Village of Bayside
9075 N. Regent Rd.
Architectoral Review Committee Meeting
July 02, 2018
Village Hall Board Room, 6:00 pm

**ARCHITECTURAL REVIEW COMMITTEE
AGENDA**

Attention:
Village of Bayside, WI
Architecture Review Committee

<p>PROJECT/SITE OWNER: Ava Habibi</p> <p>PROJECT ADDRESS: 515 W Fairy Chasm Road</p>	<p>PROJECT SUMMARY: New 4' tall, 50% open, wood fence in side and rear yards. 318ft long.</p>
--	--

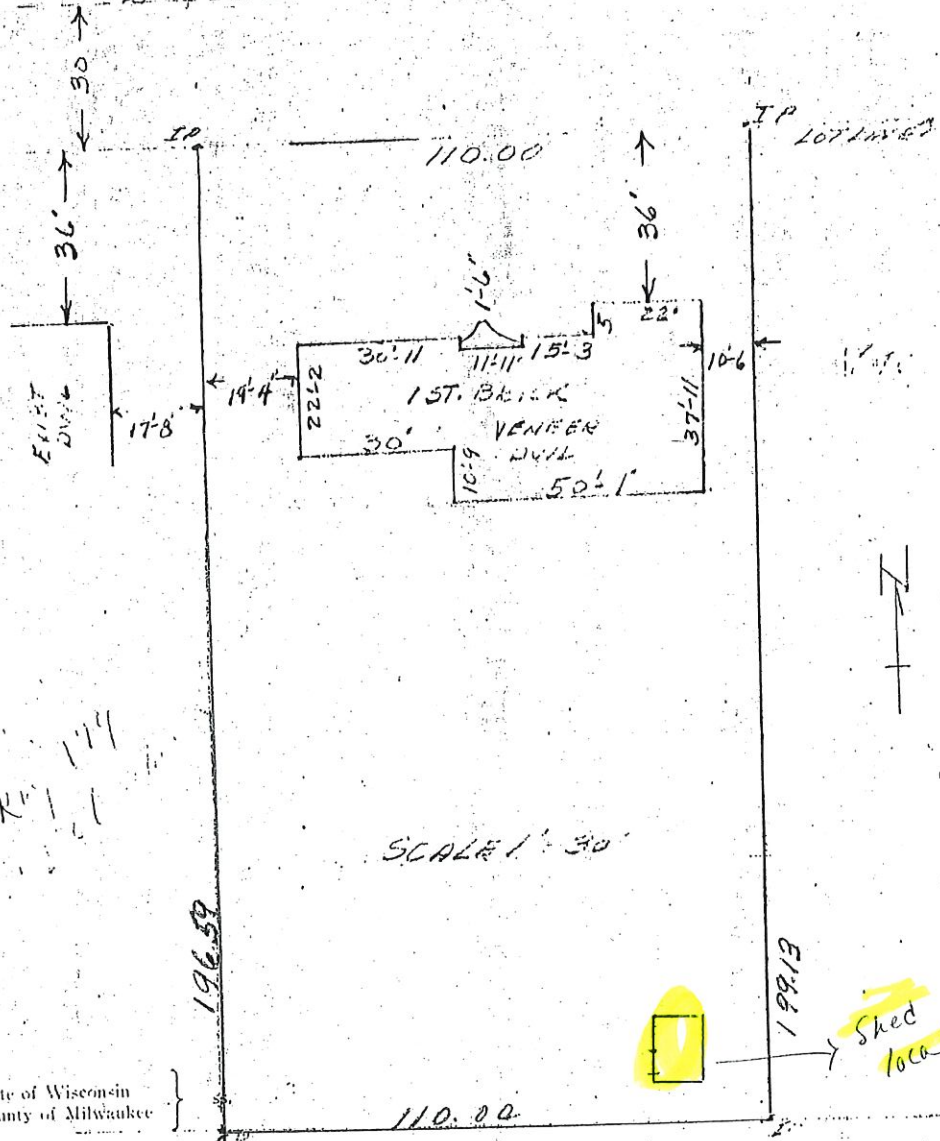
Exact dimensions are not provided for the location of the new shed. Village code section 125-90 - "B" residence district regulations requires that accessory structures be located a minimum of 10ft from both rear yard and side yard property lines.

VERIFY LOCATION OF SHED IS WITHIN REQUIRED SETBACKS.

PLAT OF SURVEY

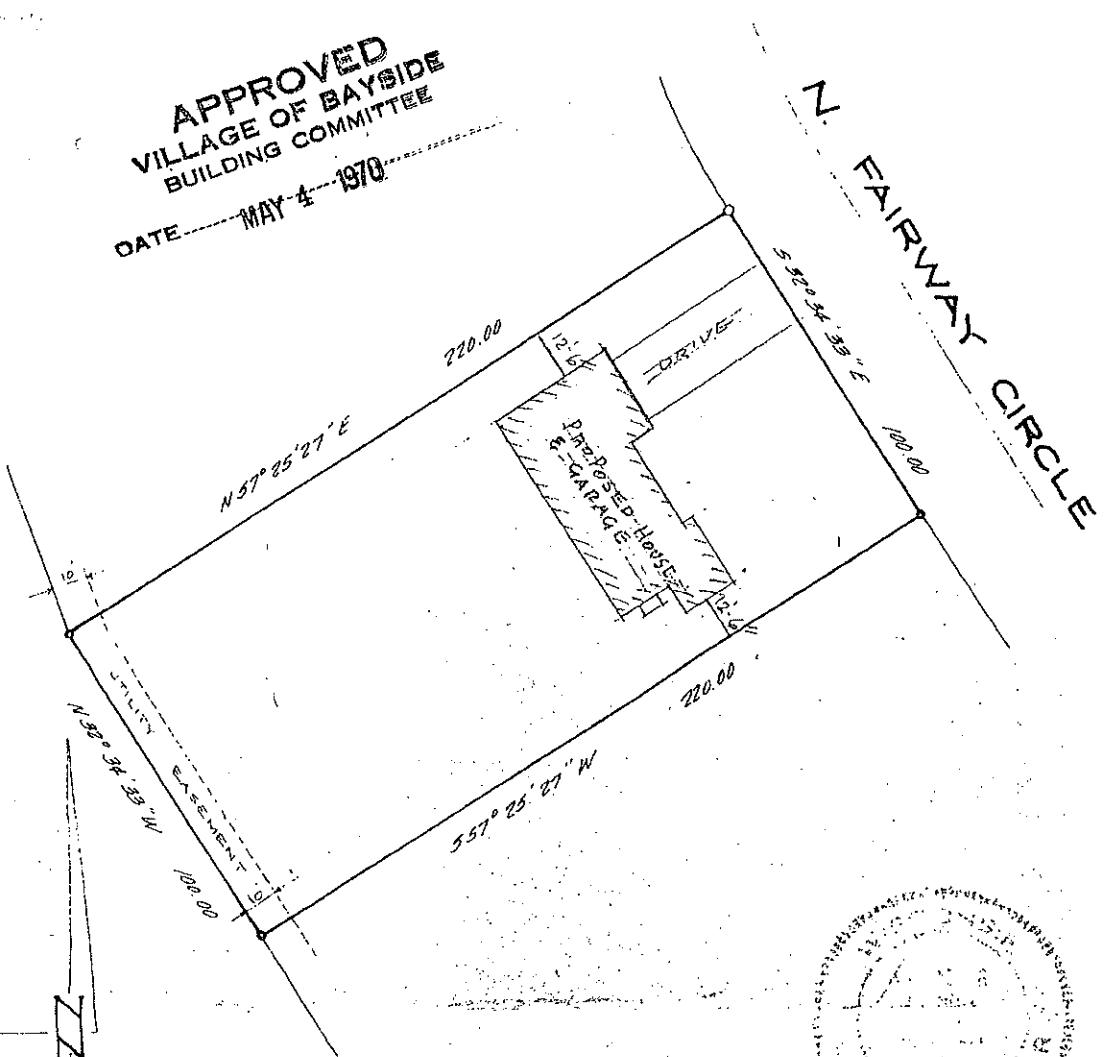
Proposed length of 318' is approximately 50% of the total property perimeter length of approximately 640' and a 50% open design is required by the code section copied below. A privacy fence is proposed which does not comply with the code section below.

Village code section 14-182 (l): Fence type. *No solid fence may be constructed with a total horizontal linear length in excess of ten percent of the total linear feet of the perimeter of the property except as screening along an adjacent railroad, state highway, interstate highway, county highway, or commercial parking lot property. No fence shall be constructed with a total horizontal linear length in excess of ten percent of the linear feet of the perimeter of the property without at least a 25 percent open design. No fence shall be constructed with a total horizontal linear length in excess of 25 percent of the linear feet of the perimeter of the property without at least a 50 percent open design.*

PROPOSED LENGTH AND TYPE DO NOT COMPLY
